**FORM VT-3C**  
 CONTAINMENT INSERVICE INSPECTION  
 RECORD OF VT-3C EXAMINATION

STATION/UNIT: Indian Point 2 COMPONENT NO.: VCC-05  
 ZONE NUMBER: IWL-043-002 DRAWING NO.: 320842  
 EQUIPMENT USED: Mag-Lite flashlight (see note 4)

Work Order No. NP-99-11274

**CONCRETE INSPECTION ZONE IWL-068-001**  
 (EXTERIOR DEVELOPED VIEW, LOOKING FROM OUTSIDE)

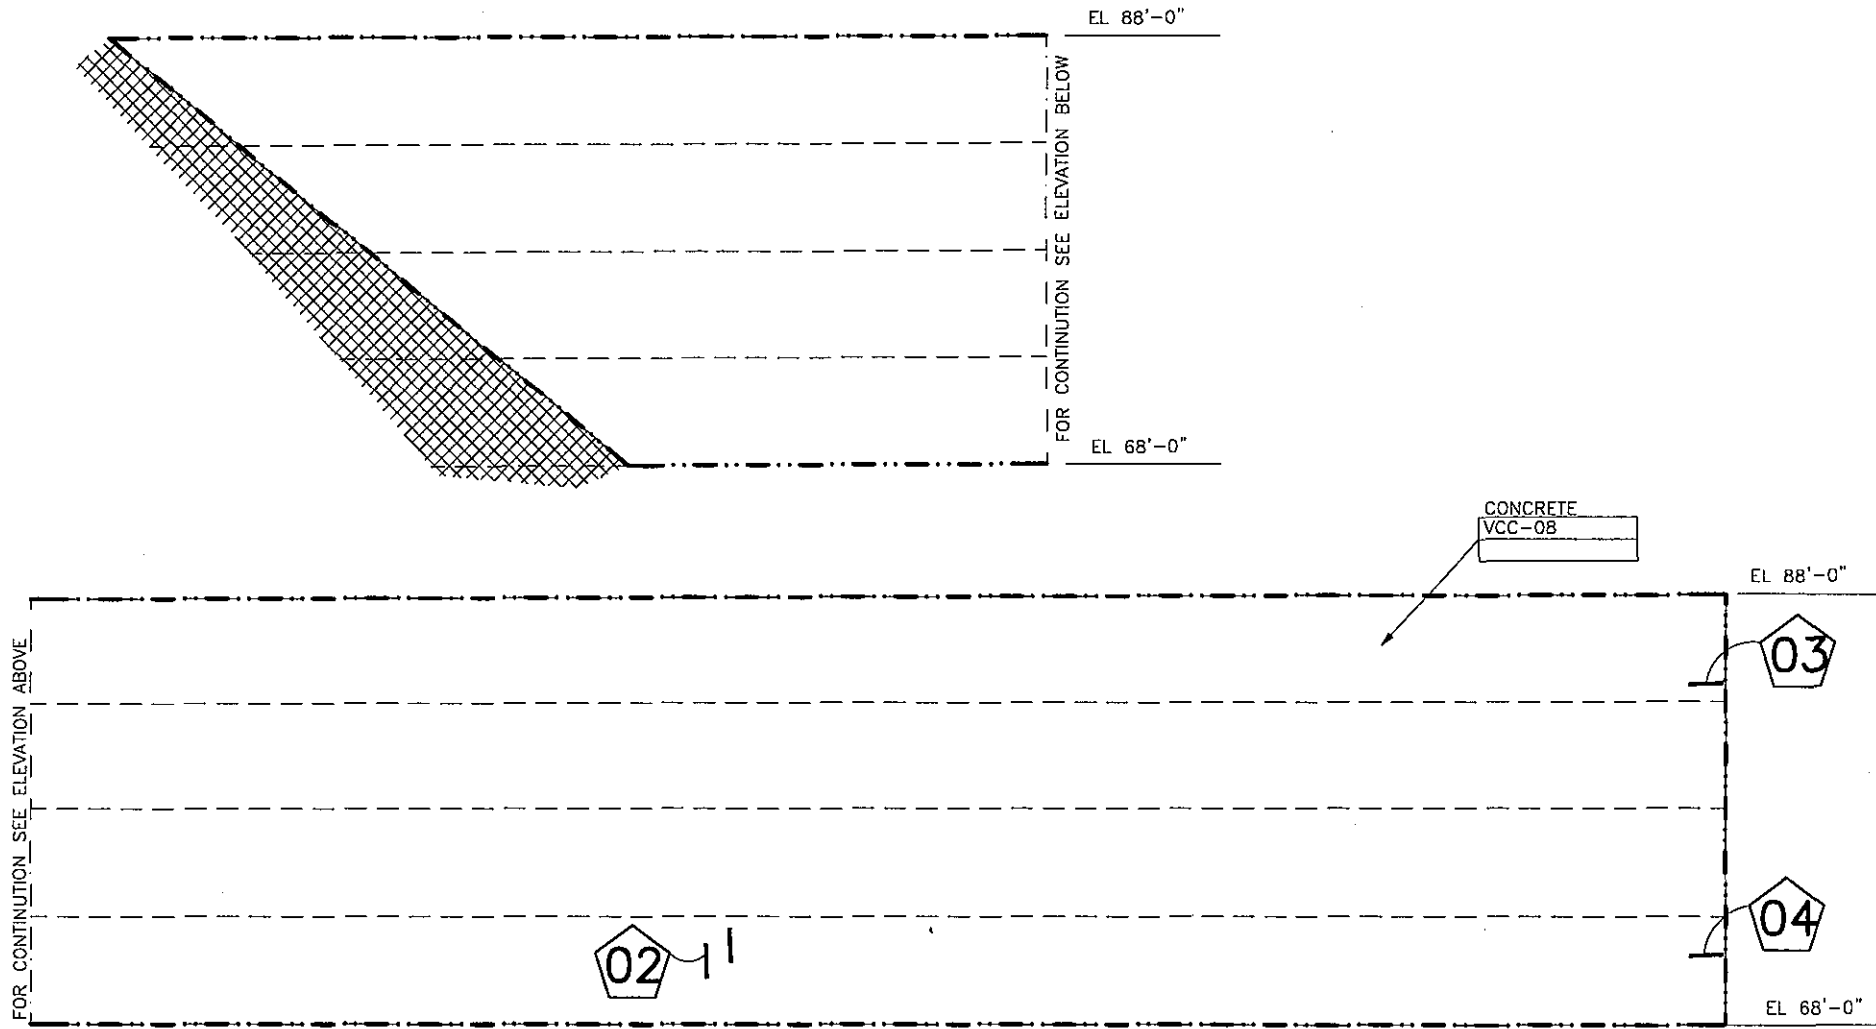
No.	Comment	Initials
1	Non-uniformity of surface color and texture observed at various locations in the zone. The condition does not indicate significant material deterioration of the concrete.	RW
2	2' long white deposits (2), 2' apart	RW
3	Rust stain from surface attachment plate	RW
4	Rust stain from surface attachment plate	RW

Comments: The indications observed are not significant relative to containment integrity.

**CONCRETE INSPECTION ZONE IWL-043-002**  
 (EXTERIOR DEVELOPED VIEW, LOOKING FROM OUTSIDE)

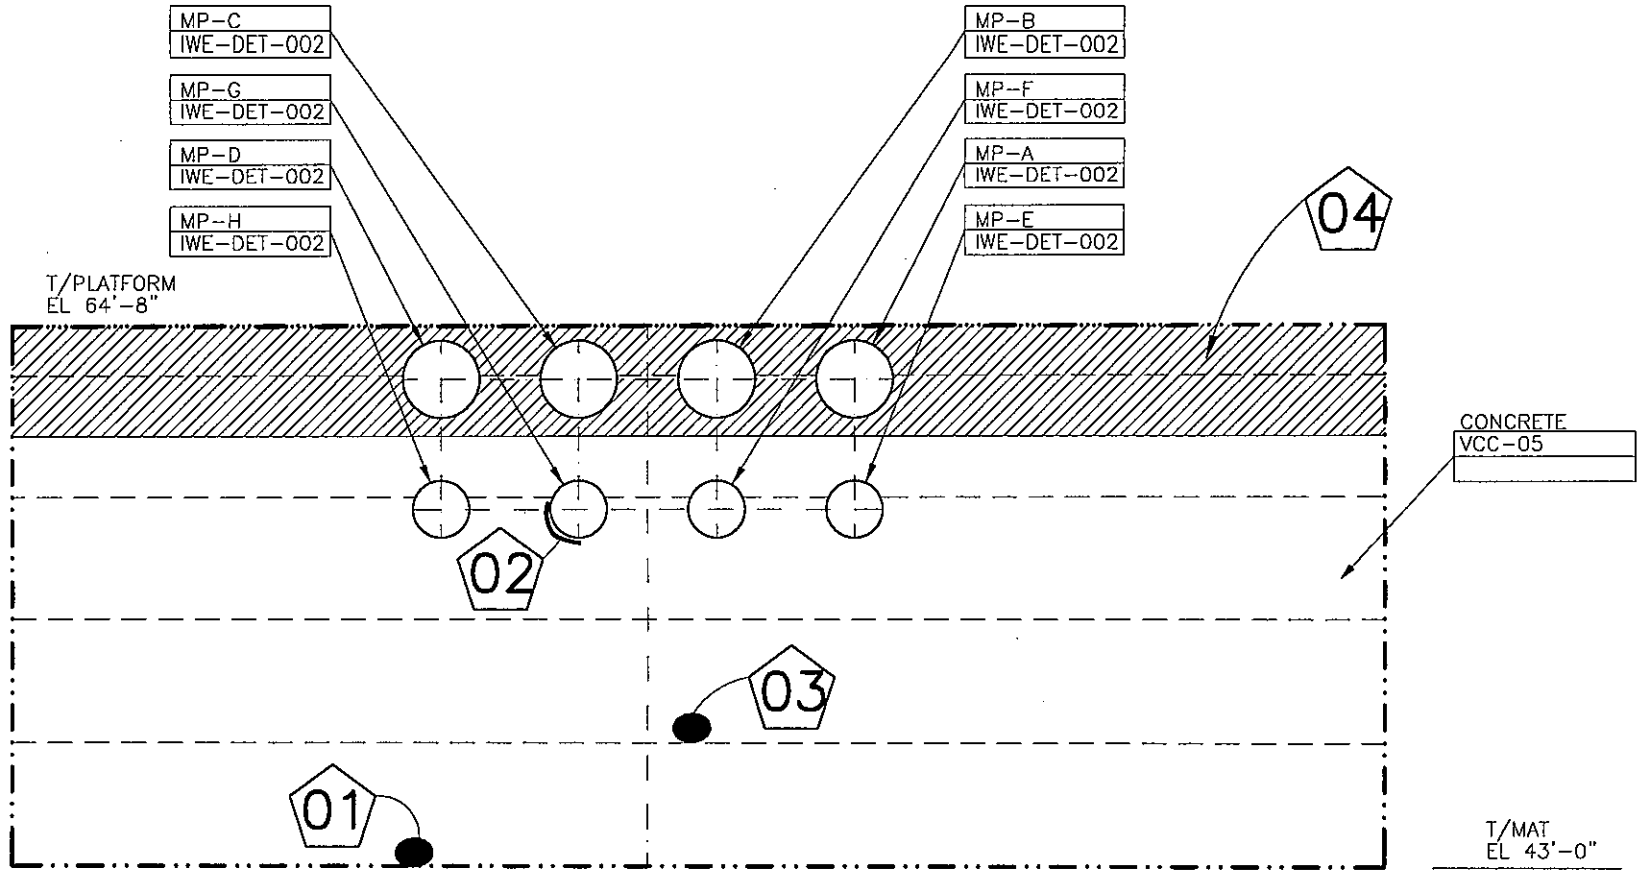
No.	Comment	Initials
1	A spalled area approximately 10" long was found at the floor line directly below penetration MP-H. This area appears to have some unconsolidated concrete ("honeycomb") from the original placement of the concrete. See Photo 00060131	CAS
2	A crack with apparent delamination was found around the lower left edge of penetration MP-G. See Photo 00060132	CAS
3	A delamination was found at approx. El. 49' directly below penetration MP-F. The area was estimated to be 18" wide by 12" high by sounding the concrete (tapping the surface with a metal object). See Photos 00060133 and 00060134.	CAS
4	This area was examined from the floor level at El. 43'. The examination distances were a maximum of 20 feet. While this distance exceeds the limits for direct visual examination, it was too short for use of the binoculars due to their minimum focal length. Lighting levels using the flashlight exceeded the 50 foot-candle requirement. The upper 5 feet of this zone were not visible for inspection by direct line of sight due to piping and structural steel obstructions.	CAS

5	There are a number of areas within this zone where the coating is flaking and peeling. There is no evidence that this is due to degradation of the concrete substrate. It is a coatings related issue and not containment degradation.	CAS

Comments : The areas with coating deterioration (comment #5) do not exhibit any degradation of the concrete substrate and therefore are not significant relative to containment integrity. The spalling and cracking (comments #1, 2, 3) require evaluation.

**CONCRETE INSPECTION ZONE IWL-068-003**  
 (EXTERIOR DEVELOPED VIEW, LOOKING FROM OUTSIDE)

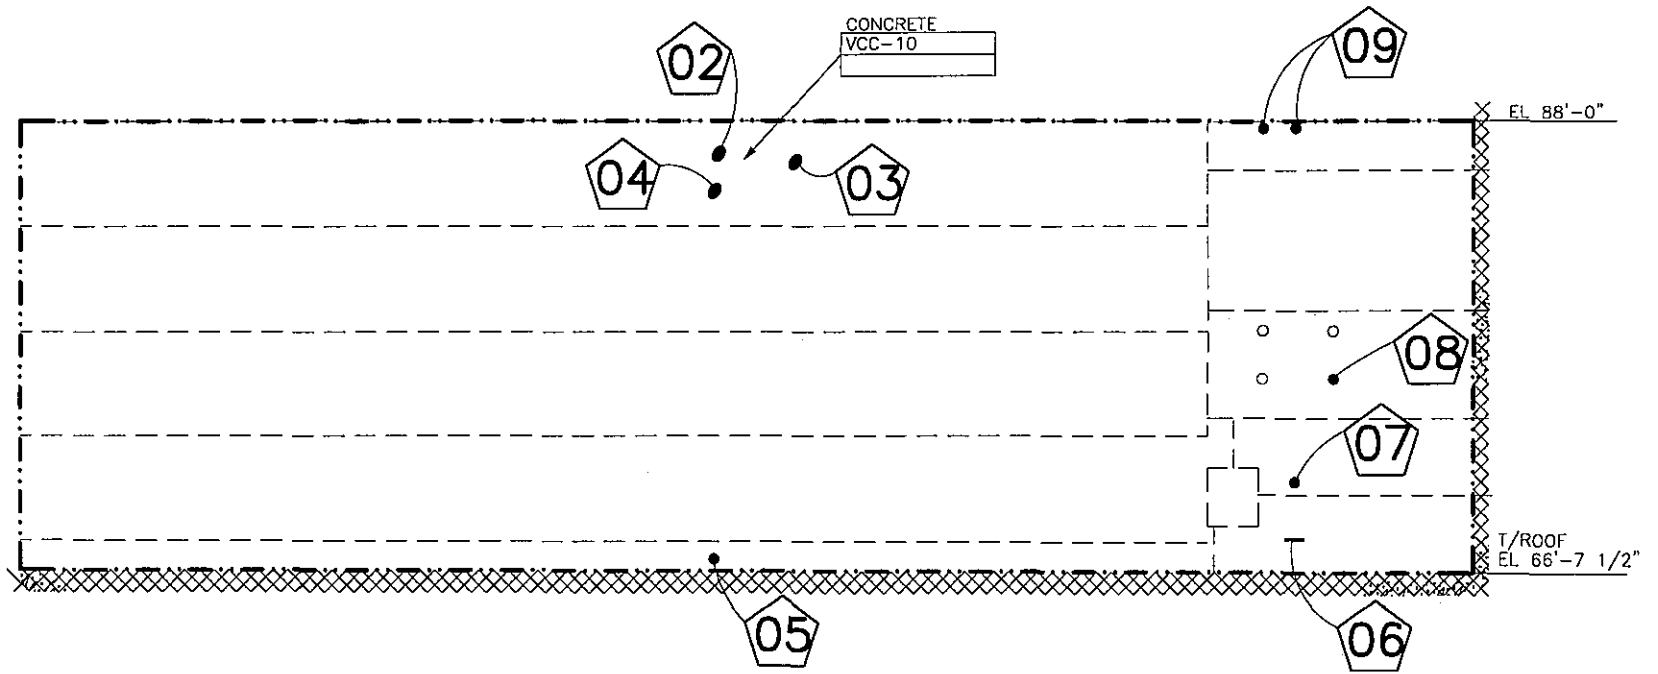
No.	Comment	Initials
1	Non-uniformity of surface color and texture observed at various locations in the zone. The condition does not indicate significant material deterioration of the concrete.	CAS
2	Small rust spot visible on concrete surface. It could be tie wire or other misc. steel but does not appear to be rebar. See photo 00053120	CAS
3	Small rust spot visible on concrete surface. It could be tie wire or other misc. steel but does not appear to be rebar. See photo 00053121	CAS
4	Small rust spot visible on concrete surface. It could be tie wire or other misc. steel but does not appear to be rebar. See photo 00053122	CAS
5	Small rust spot visible on concrete surface. It could be tie wire or other misc. steel but does not appear to be rebar. See photo 00053123	CAS
6	Exposed cadweld with some rusting. See photo 00053124	CAS
7	Small rust spot visible on concrete surface. It could be tie wire or other misc. steel but does not appear to be rebar. See photo 00053125	CAS

8	Form tie hole which was not filled. This is not significant relative to containment structural integrity.	CAS
9	Two small rust spots visible on concrete surface. It could be nails, form ties or other misc. steel but does not appear to be rebar. See photo 00053126	CAS

Comments : The exposed cadweld (comment #6) requires evaluation. The other observed conditions are not significant relative to containment integrity.

**CONCRETE INSPECTION ZONE IWL-088-002**  
 (EXTERIOR DEVELOPED VIEW, LOOKING FROM OUTSIDE)

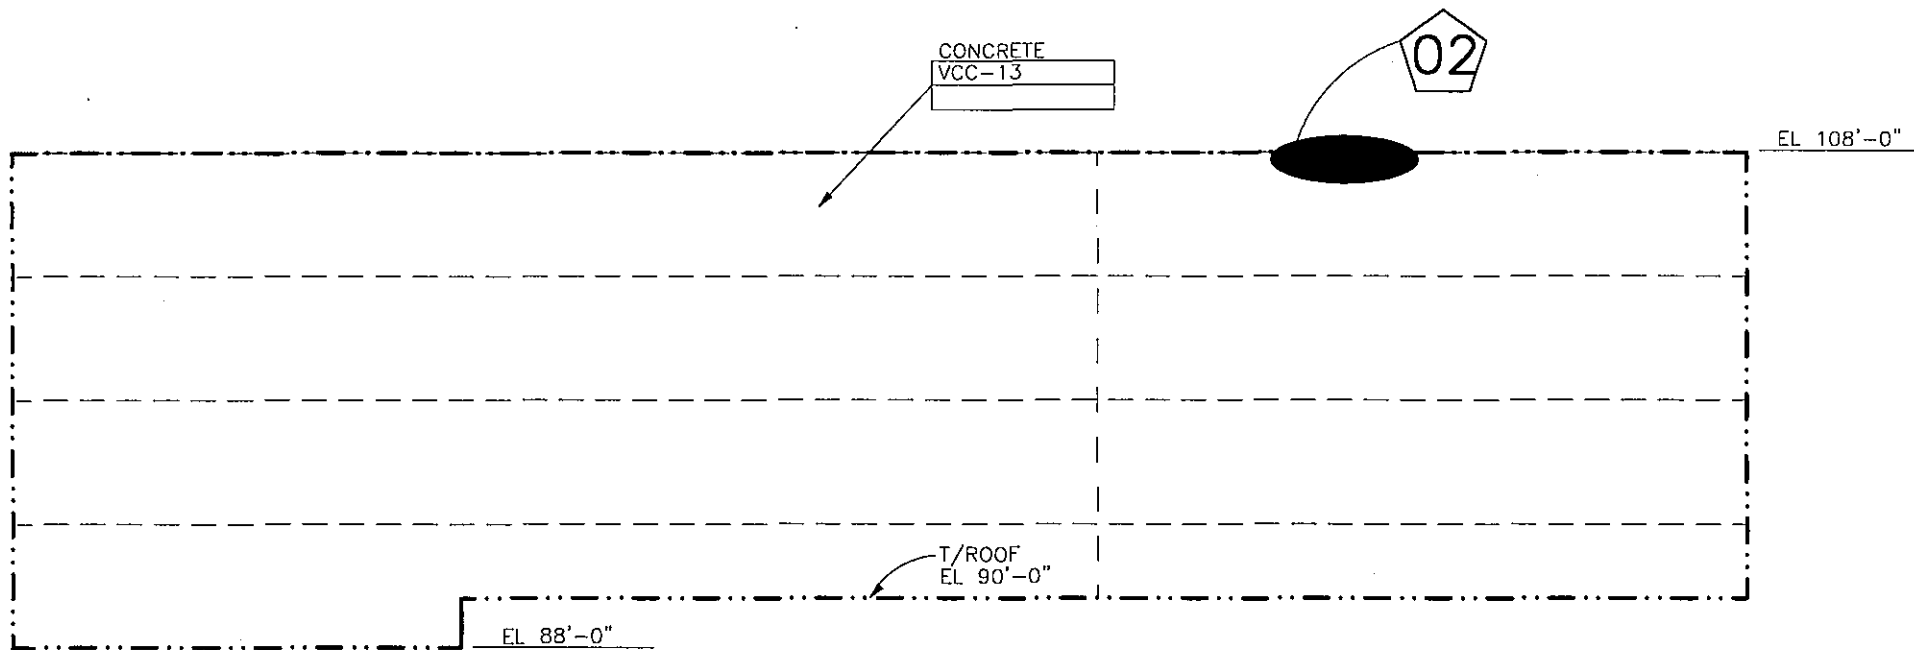
No.	Comment	Initials
1	Non-uniformity of surface color and texture observed at various locations in the zone. The condition does not indicate significant material deterioration of the concrete.	CAS
2	An area approximately 4' long by 1' high near the top of the zone & in line with the southern most relief valve silencer has aggregate exposed due to loss of surface paste. See photo 00053135	CAS

Comments: The observed conditions remain from the original concrete placement and do not reflect any ongoing degradation.

**CONCRETE INSPECTION ZONE IWL-088-003**  
(EXTERIOR DEVELOPED VIEW, LOOKING FROM OUTSIDE)

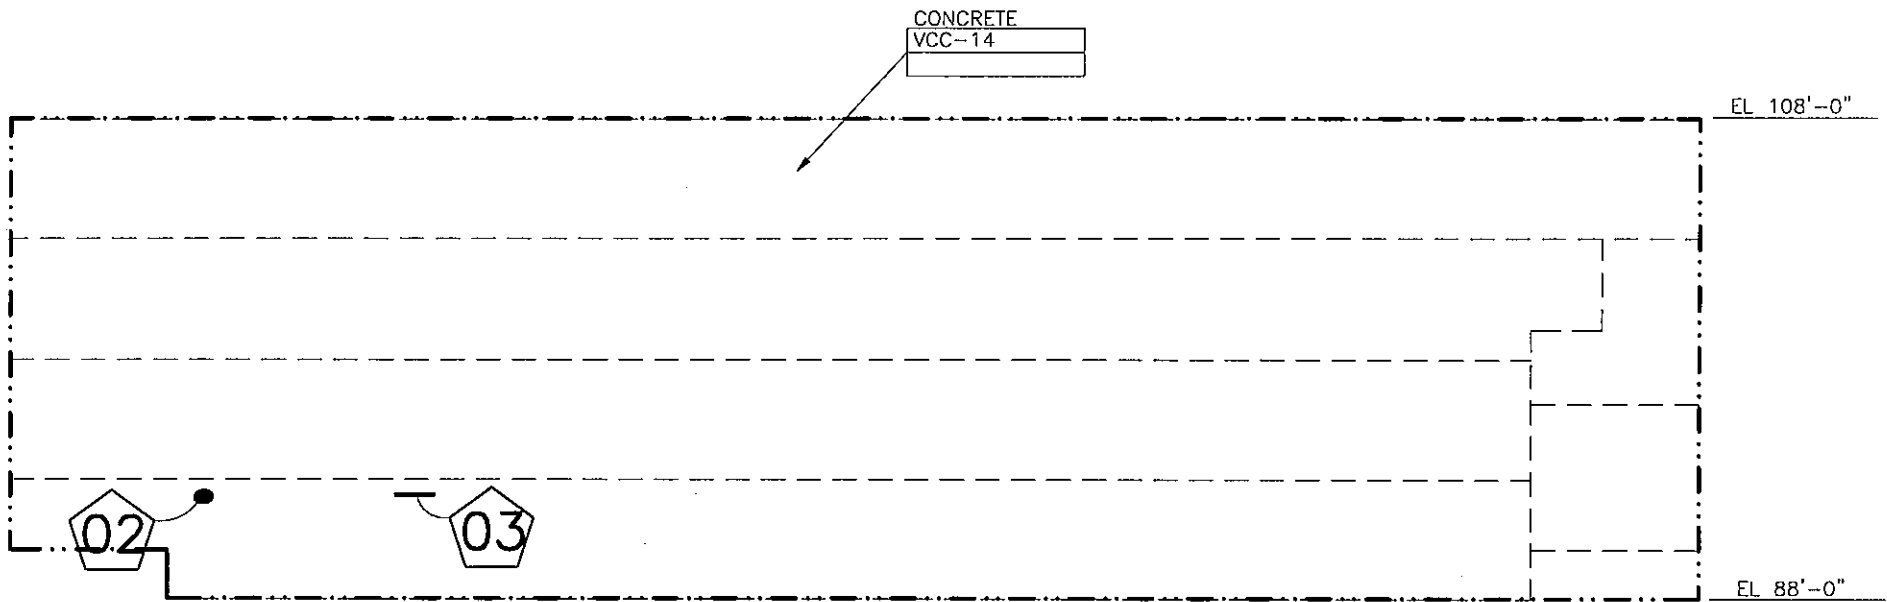
No.	Comment	Initials
1	Non-uniformity of surface color and texture observed at various locations in the zone. The condition does not indicate significant material deterioration of the concrete.	CAS
2	A small section of reinforcing steel is exposed and is corroded. Based on its size and orientation it does not appear to be main reinforcing steel but could be a shear bar. See photo 00053130	CAS
3	A small section of reinforcing steel is exposed and is corroded. Based on its size and orientation it does not appear to be main reinforcing steel but could be a shear bar. See photo 00053131	CAS

Comments : The exposed bars require further evaluation. The condition described in comment #1 originated from original construction and does not reflect degradation.

**CONCRETE INSPECTION ZONE IWL-088-004**  
 (EXTERIOR DEVELOPED VIEW, LOOKING FROM OUTSIDE)

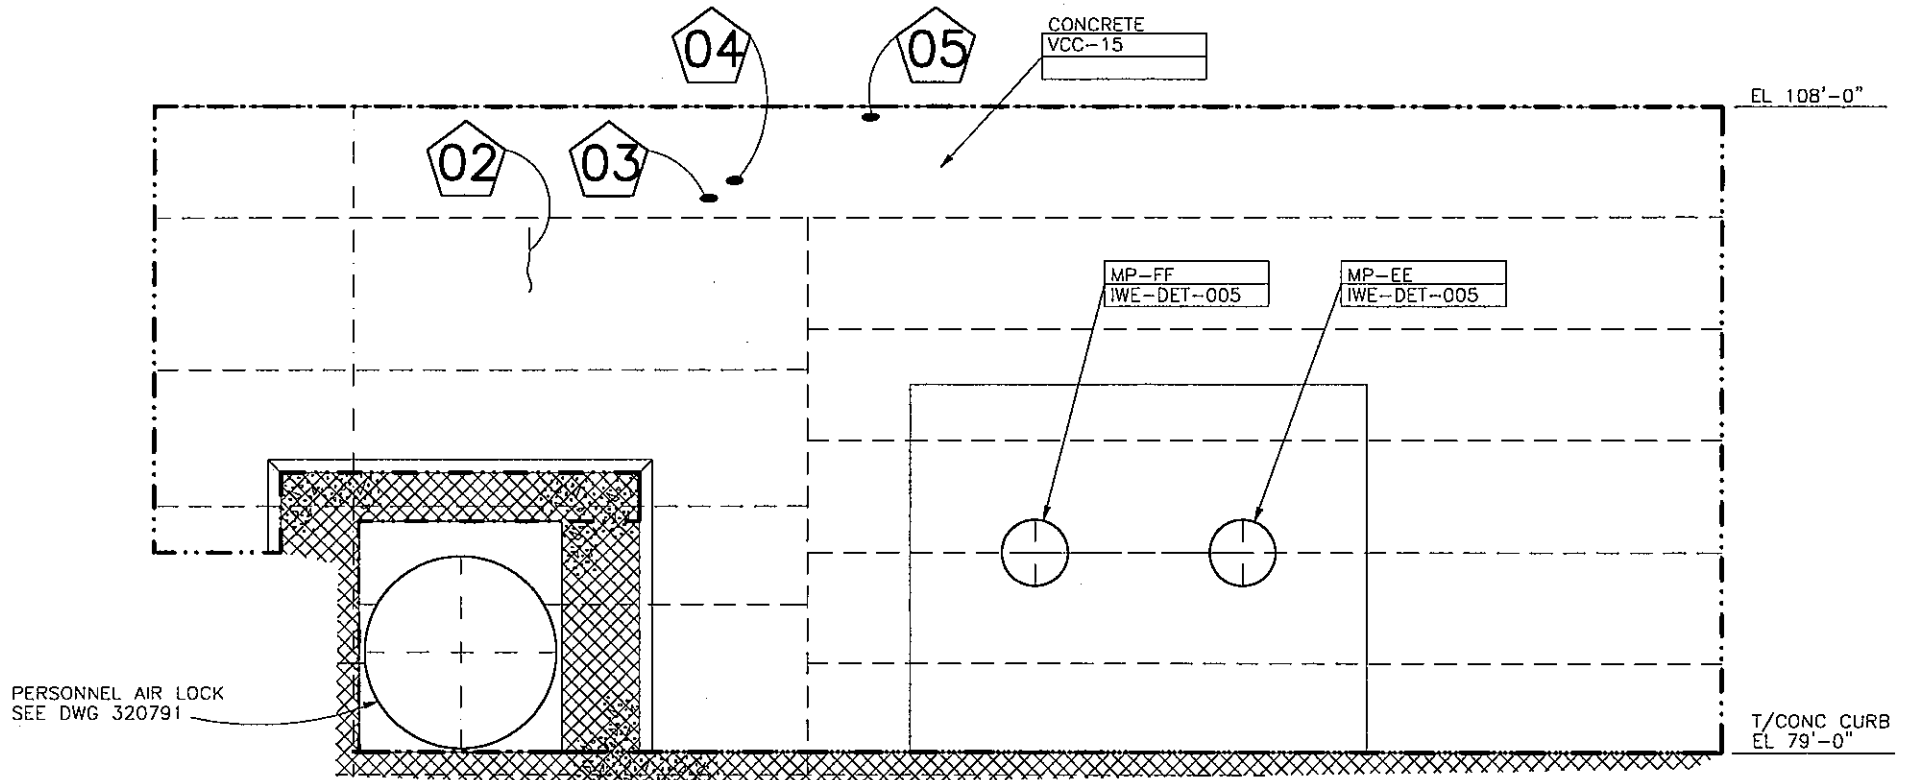
No.	Comment	Initials
1	Non-uniformity of surface color and texture observed at various locations in the zone. The condition does not indicate significant material deterioration of the concrete.	RW
2	2' long white deposit from top of construction opening closure grout. See photo 00052616	RW
3	Concrete spall about 8" square area about to popout. See photo 00052613	RW
4	Rebar exposure accompanied by 4" concrete spall. See photo 00052613	RW
5	10"x4" concrete spall exposing 8" length of cadweld sleeve. Only 1/2" concrete cover in this area. See photo 00052615	RW

Comments: Engineering evaluation IS required for the conditions noted in comments #3 #4 & #5. The other conditions are not significant relative to containment integrity.

**CONCRETE INSPECTION ZONE IWL-108-001**  
(EXTERIOR DEVELOPED VIEW, LOOKING FROM OUTSIDE)

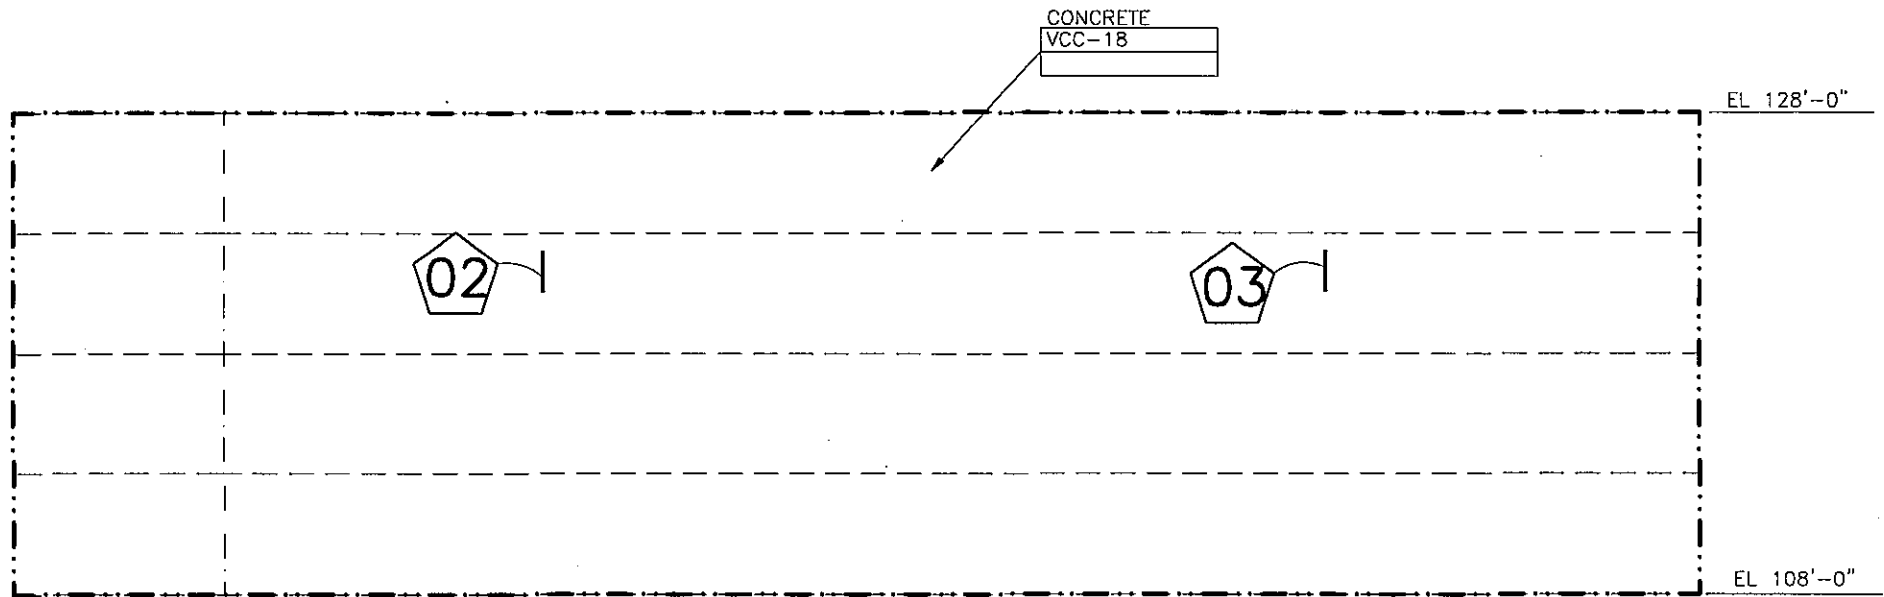
No.	Comment	Initials
1	Non-uniformity of surface color and texture observed at various locations in the zone. The condition does not indicate significant material deterioration of the concrete.	RN
2	18" long leaching from the construction joint down to the form tie hole mortar patch	RN
3	leaching about the same length as in item 2	RN

Comments: The observed conditions are not significant relative to containment integrity.
